**ST. LUCIE PLANT
UNIT 1 AND UNIT 2**

**IMPROVED TECHNICAL
SPECIFICATIONS CONVERSION**

**ITS SECTION 3.3
INSTRUMENTATION**

**Current Technical Specifications (CTS) Markup
and Discussion of Changes (DOCs)**

Figure 3.3.1-1 (page 1 of 1)
Thermal Margin/Low Pressure Trip Setpoint: ASI vs A1

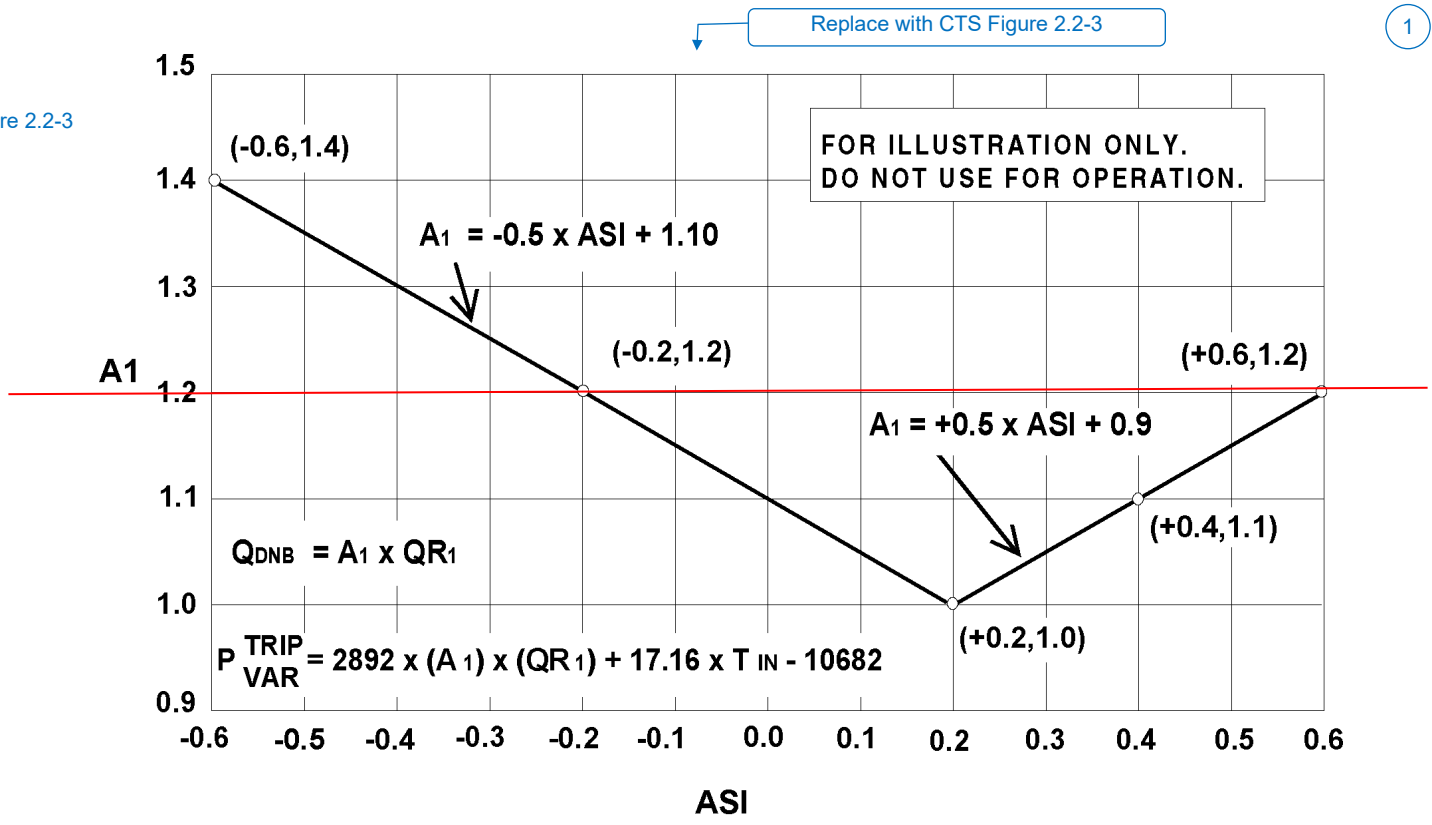
CTS

Figure 2.2-3

Figure 3.3.1-2 (page 1 of 1)
Thermal Margin/Low Pressure Trip Setpoint: Fraction of RTP vs QR 1

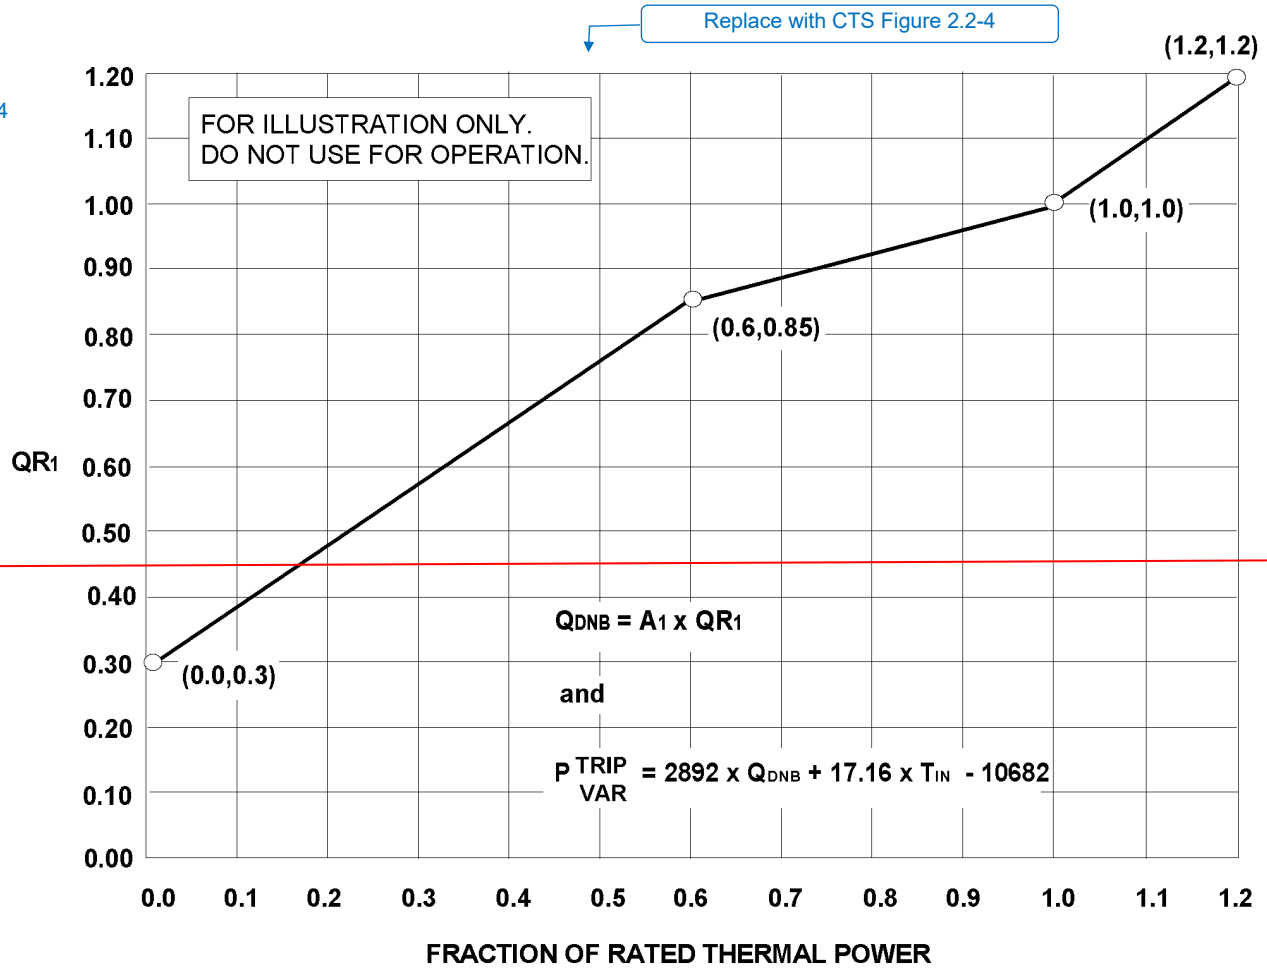
CTS

Figure 2.2-4

Figure 3.3.1-3 (page 1 of 1)
Peripheral Axial Shape Index, Y_1 vs Fraction of RTP

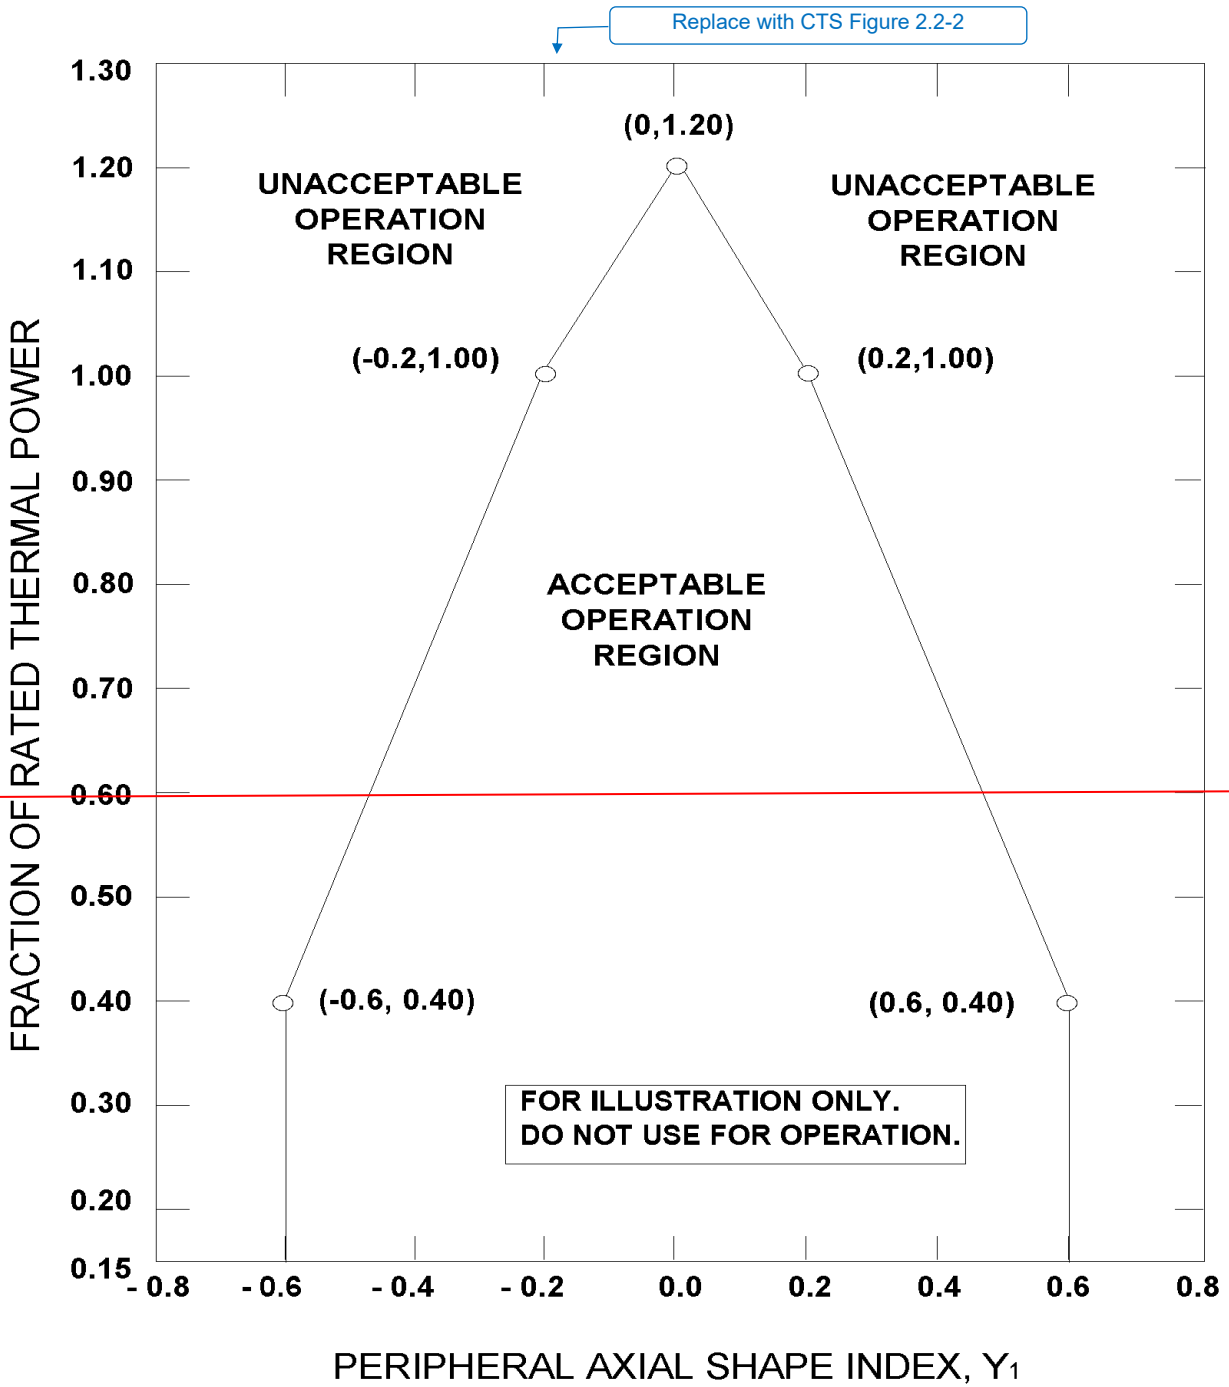
Insert CTS Figure 2.2-1

Figure 2.2-2

Figure 3.3.1-1 (page 1 of 1)
Thermal Margin/Low Pressure Trip Setpoint: ASI vs A1

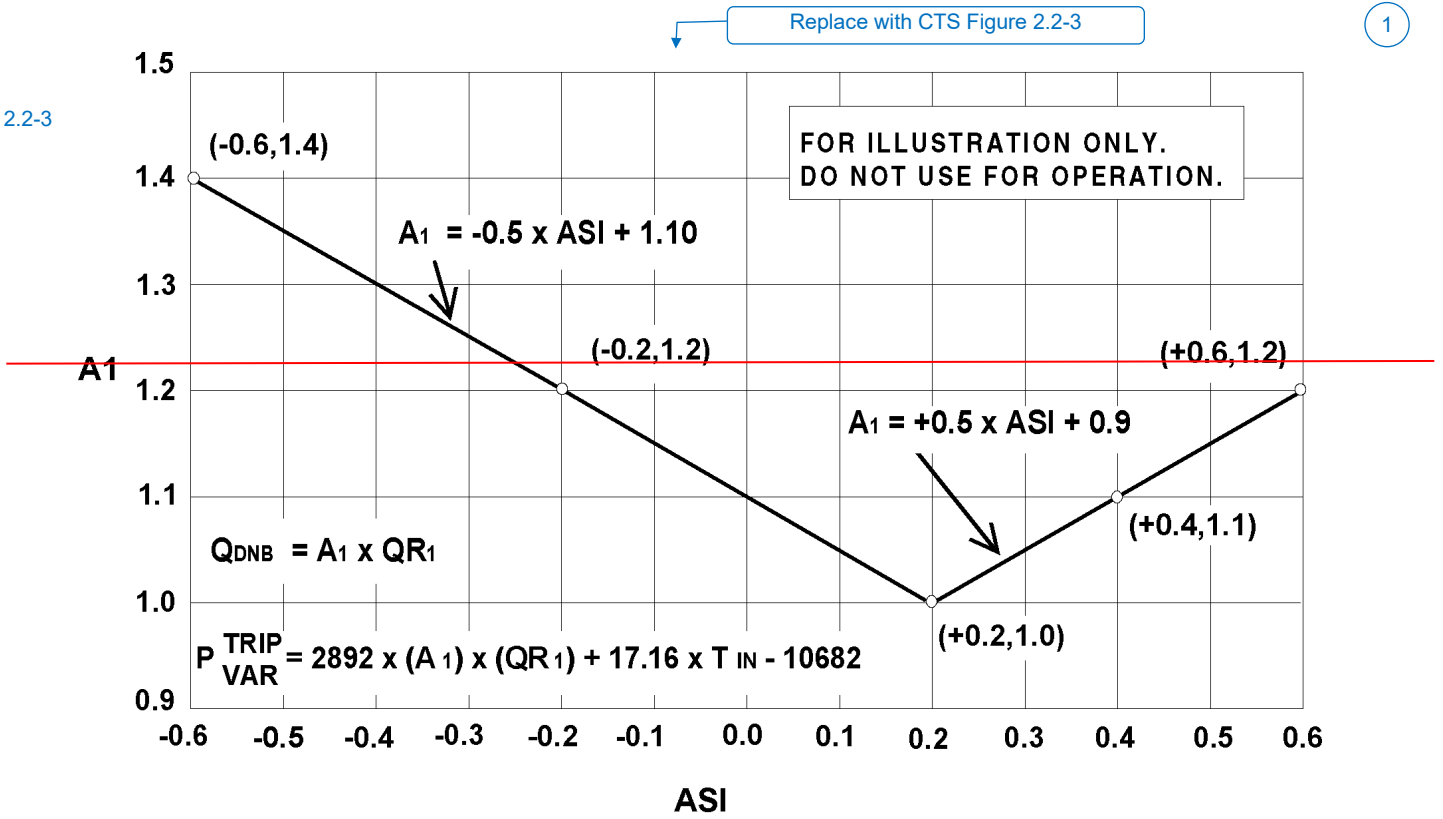
CTS

Figure 2.2-3

Figure 3.3.1-2 (page 1 of 1)
Thermal Margin/Low Pressure Trip Setpoint: Fraction of RTP vs QR 1

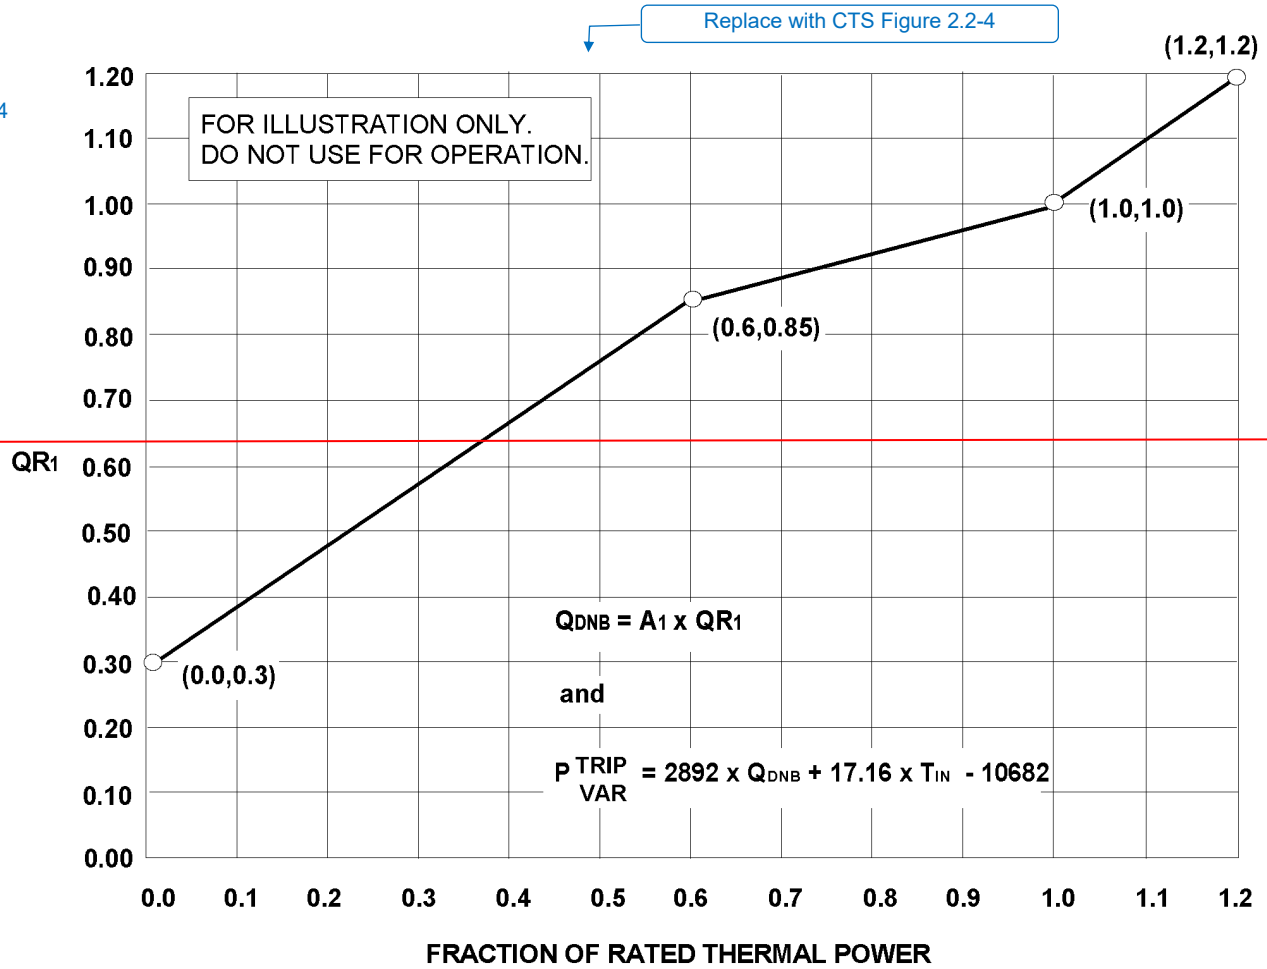
CTS

Figure 2.2-4

Figure 3.3.1-3 (page 1 of 1)
Peripheral Axial Shape Index, Y_1 vs Fraction of RTP

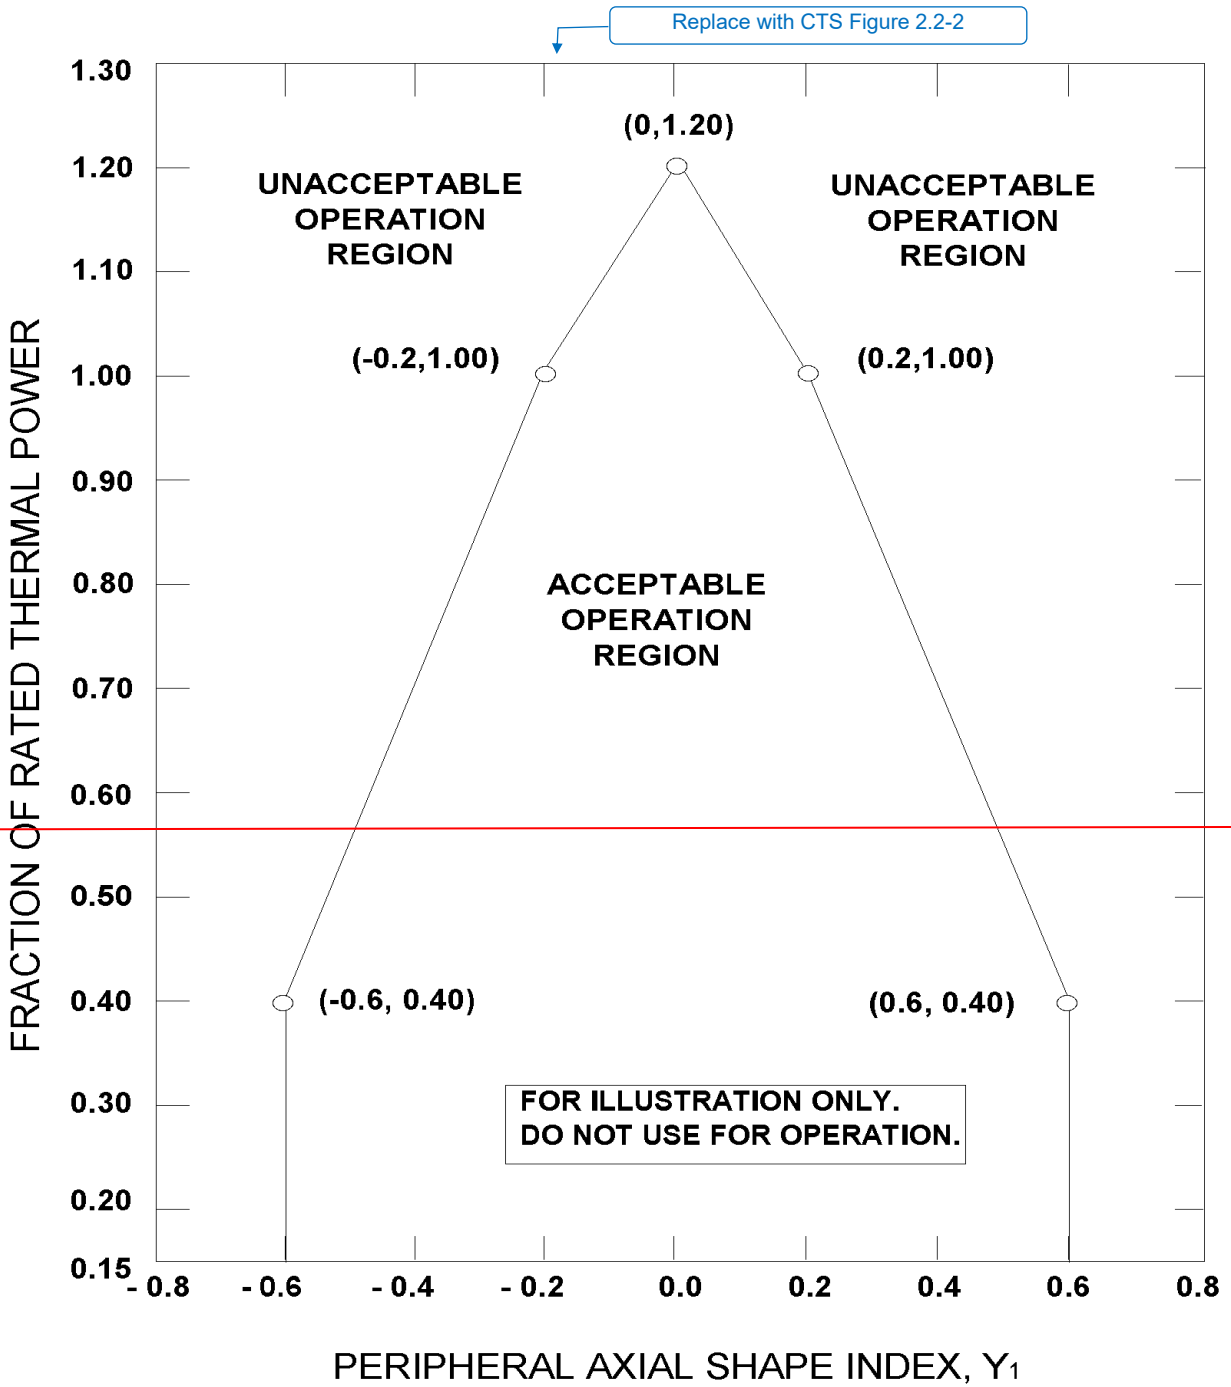
Insert CTS Figure 2.2-1

Figure 2.2-2

Figure B 3.3.1-1 (page 1 of 1)
Functional Diagram of the Two-Out-of-Four Logic and RTCB Configuration

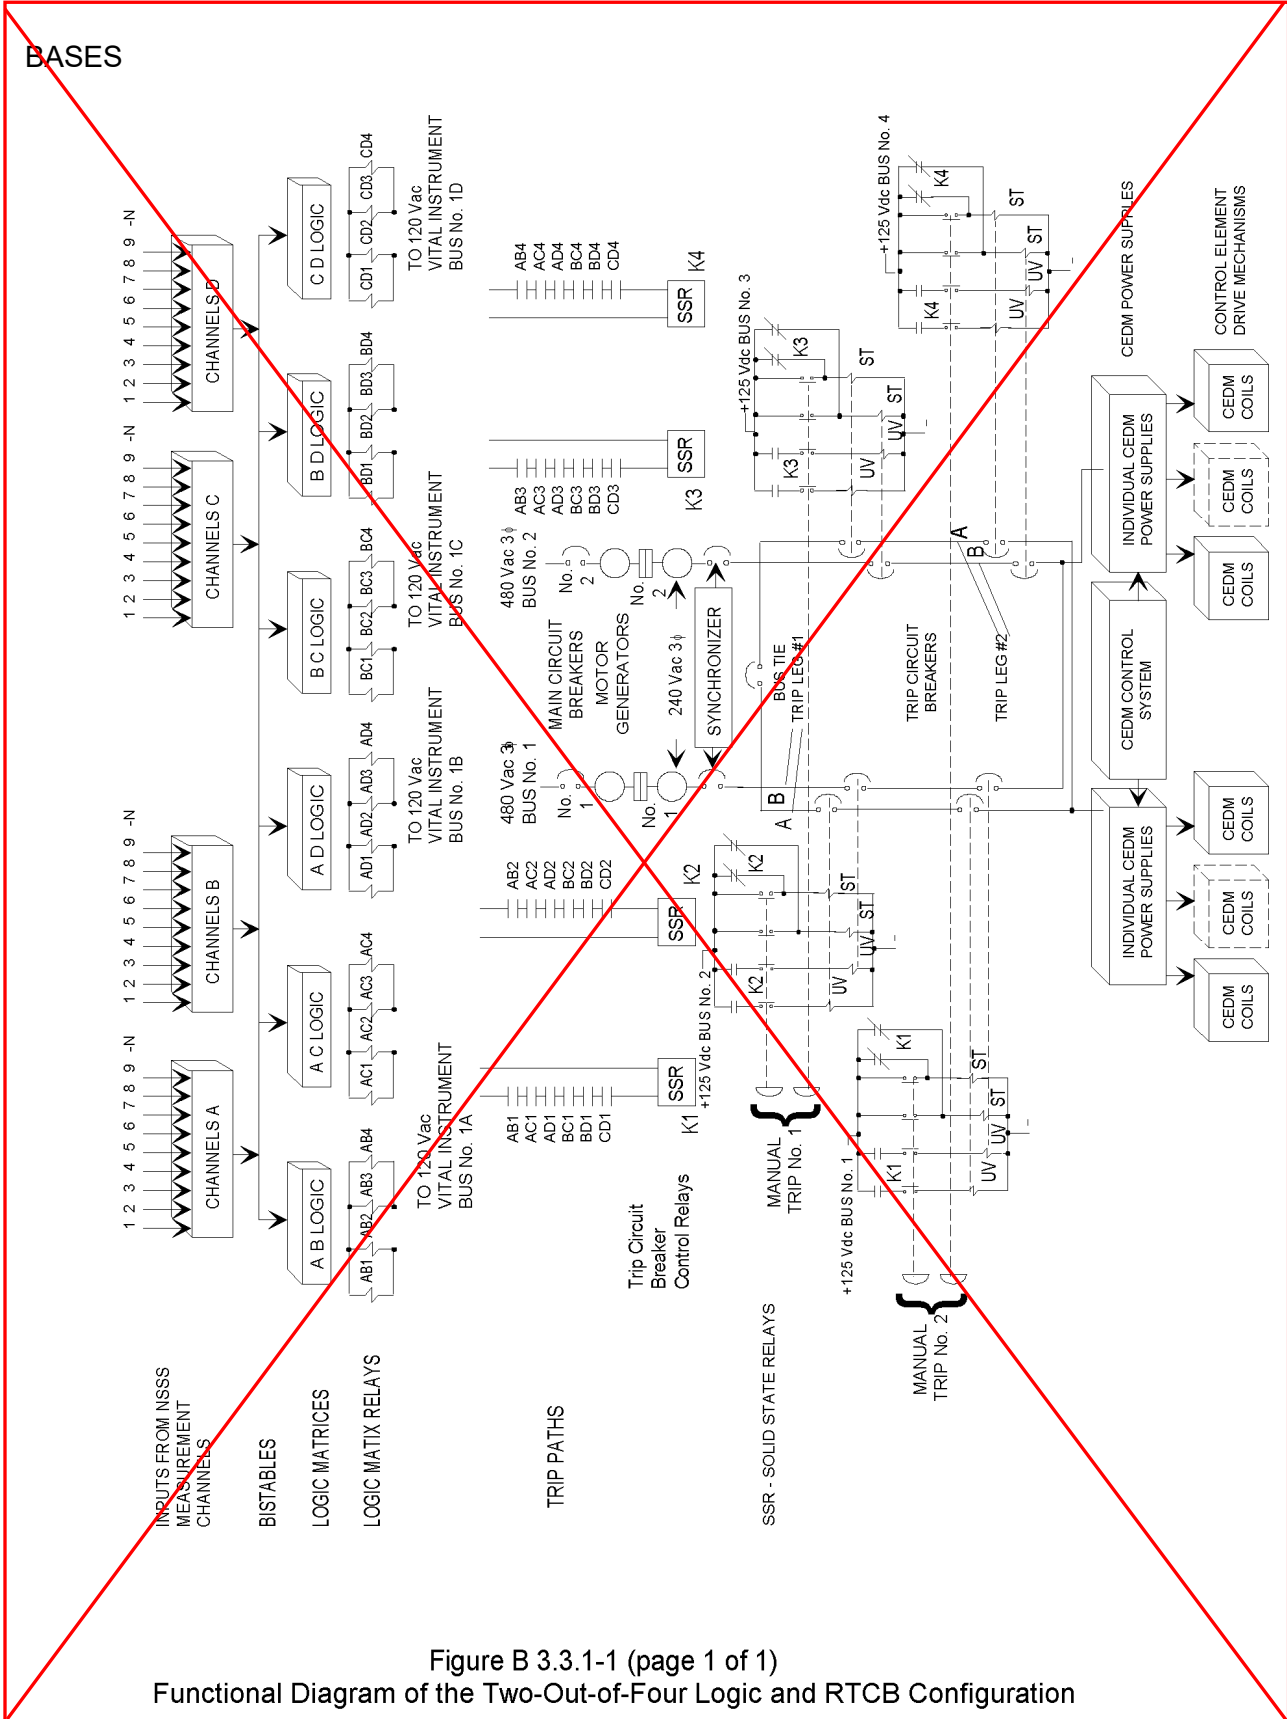
6. Figure B 3.3.1-1 is removed because the figure is included in the UFSAR.
7. Editorial clarification.
8. Changes made to reflect changes made to the Specification consistent with the current licensing basis as approved in License Amendment 243 (Unit 1) and Amendment 194 (Unit 2), dated October 31, 2017 (NRC ADAMS Accession Number ML17257A015).
